BIDDER QUERIES AND ANSWER
PAKIS-RFQ-24-027
PUMPING AND SOLRIZATION OF KOT CHANDNA, MIANWALI

Detailed Layout2

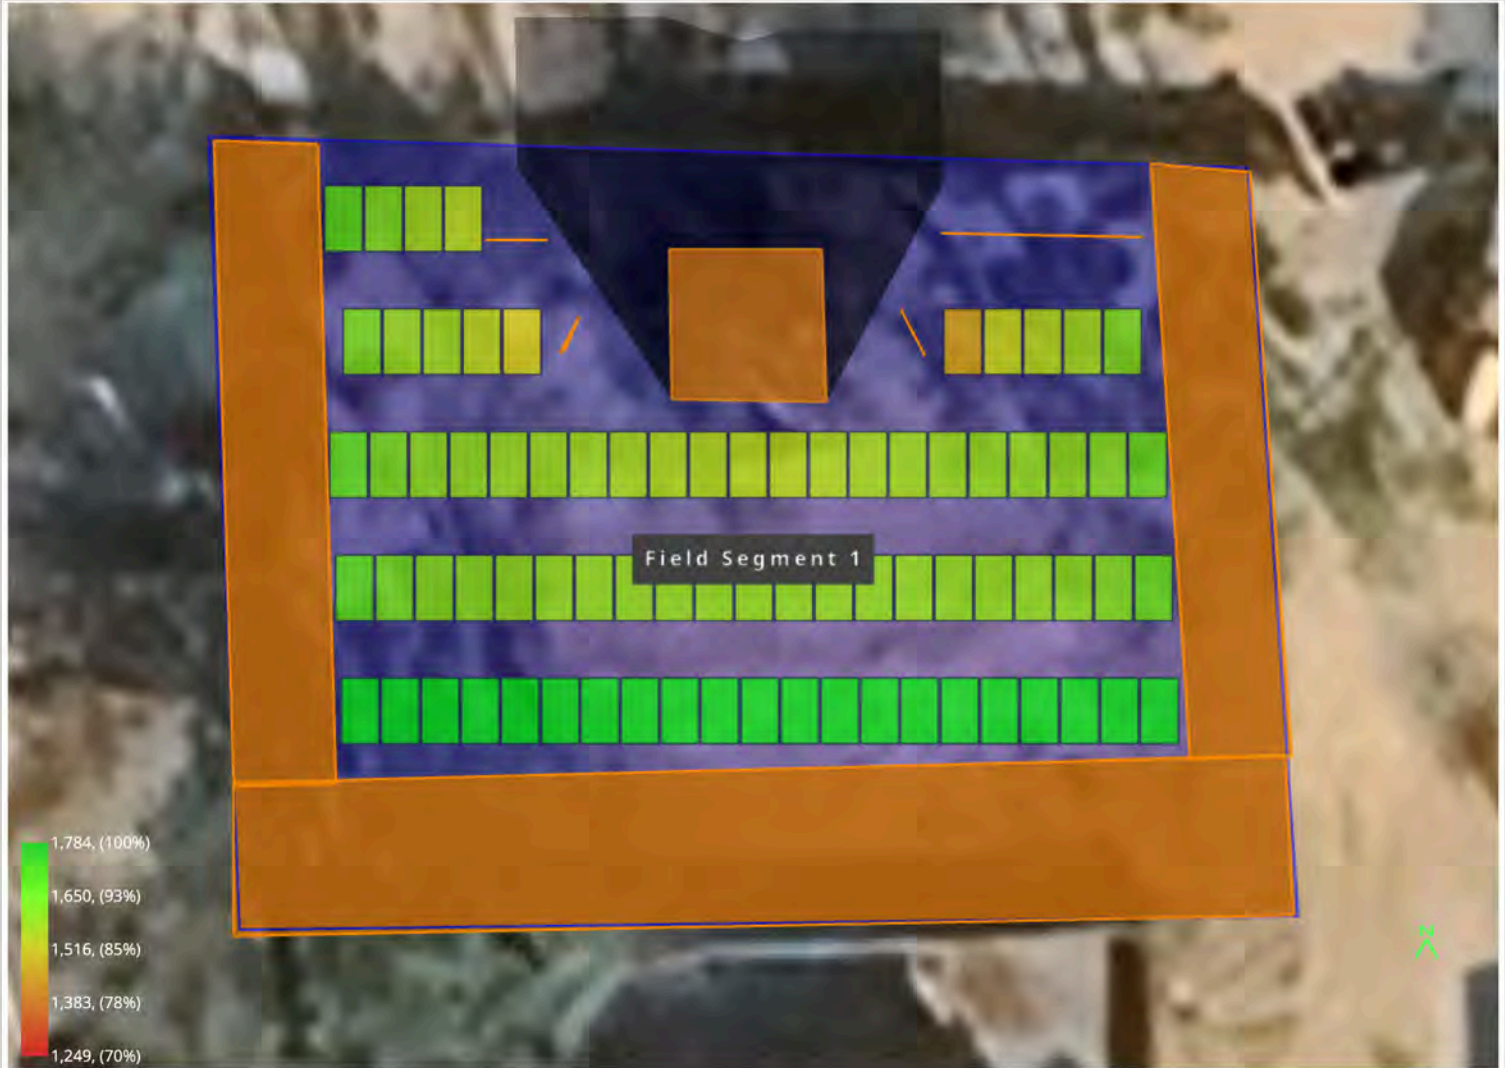
PV Module Capacity: The BOQ specifies 45,000W for the solar PV system. Can you clarify the total number of modules required, considering the wattage per panel?

Solar Panel Mounting Details: Are the mounting structures to be designed for a specific roof pitch or should they be installed to accommodate variable angles based on the geographical location of the site of Installation?

Vendor may consider a single solar panel of 585 W or higher as the system is designed on 585-Watt solar panel (77 solar panels in total). For further details, please refer to the solar design reports for all three locations under the scope of this RFQ at the end of this document.

Recommended Azimuth is 180 degree and Tilt should be 30 degrees. South facing of the Tubewell Bazar Area is clear. For further details, please refer to the solar design reports for all three locations under the scope of this RFQ at the end of this document.

Detailed Layout2

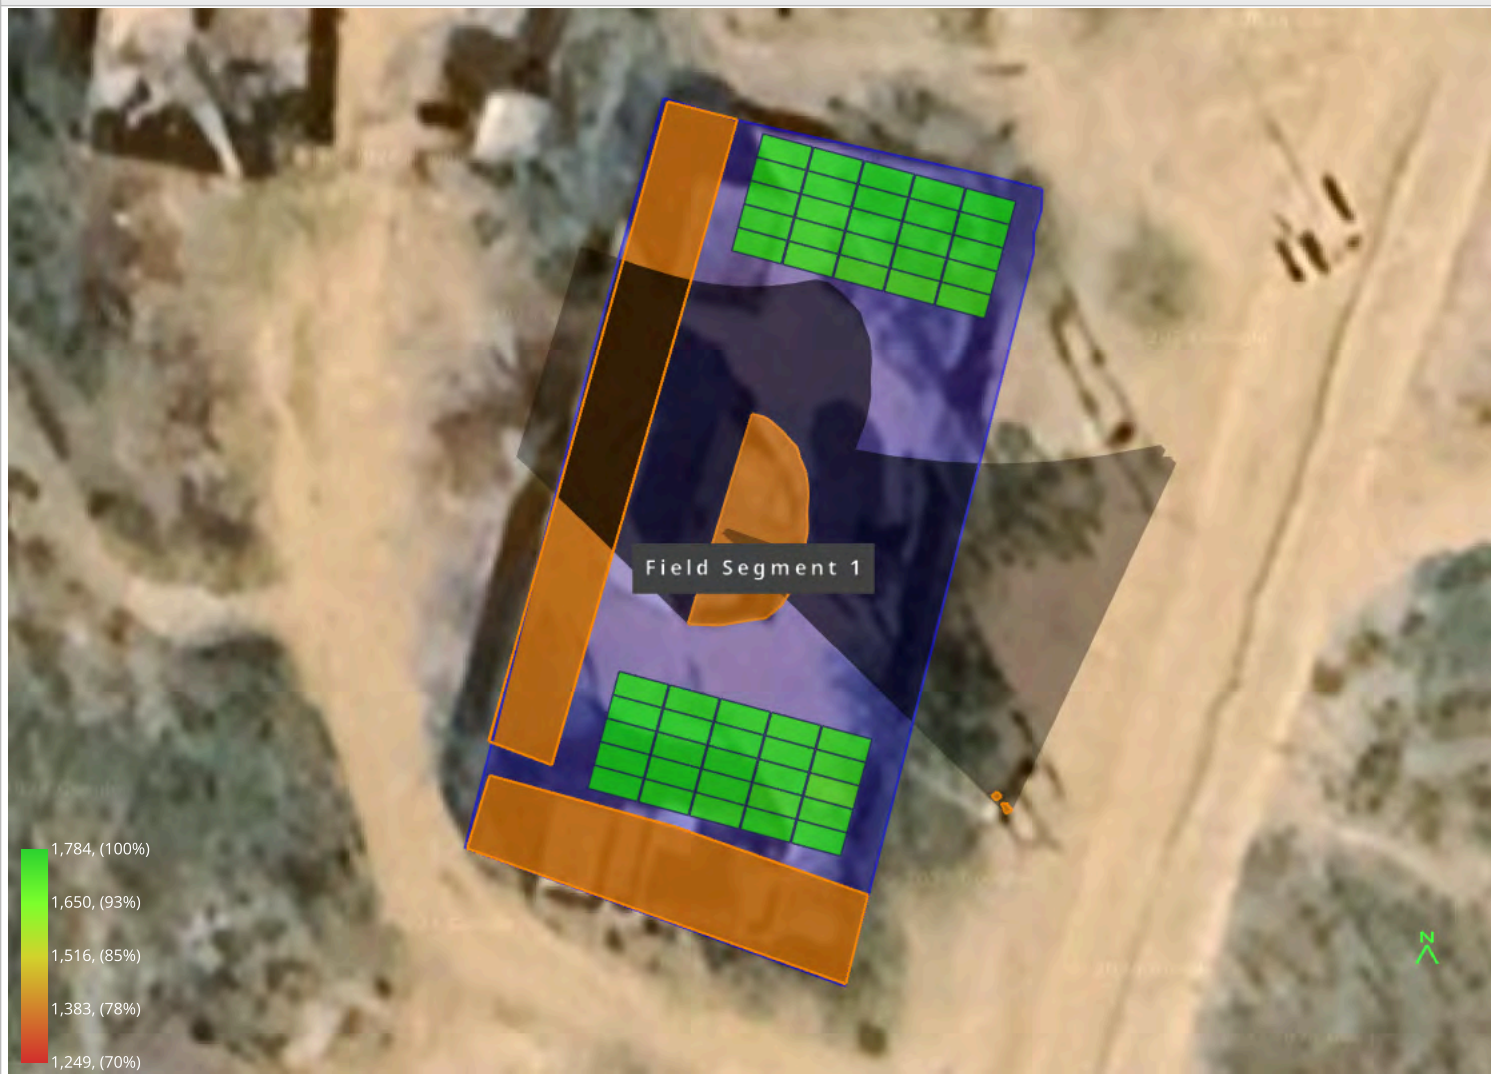
PV Module Capacity: The BOQ specifies 29,250 W for the solar PV system. Can you clarify the total number of modules required, considering the wattage per panel?

Vendor may consider a single solar panel of 585 W or higher as the system is designed on 585-Watt solar panel (50 solar panels in total). For further details, please refer to the solar design reports for all three locations under the scope of this RFQ at the end of this document.
